Access Compliance Report

Public Rights-of-Way

Intersection ID: 10019931	Main Street: ARDREY_KELL_RD	Cross Street: N/A	Location: NE
ADA ID: DF5BBF9AEDA1	Ramp Type: PerpDiag	Initial Pass/Fail: Pass	Overall Compliance: No
Codes/Mitigation Info/Possible Solution		Field Measurements/Component Compliance

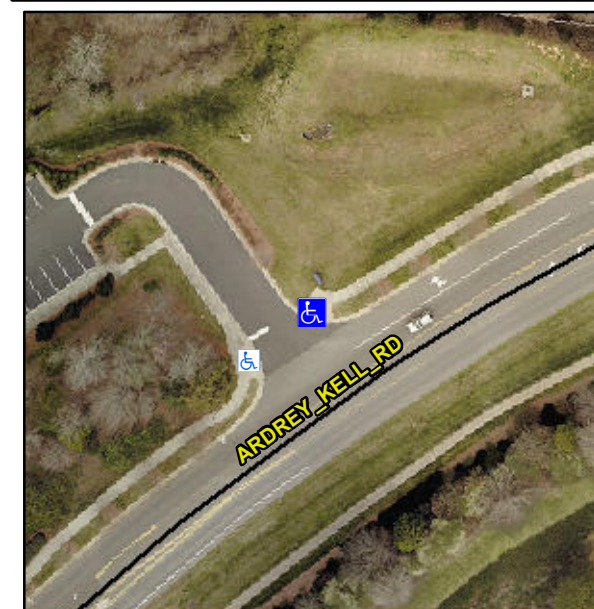
Not Found, R305.2

Remove & Replace Curb Ramp With Two New Directional Ramps or Equivalent.
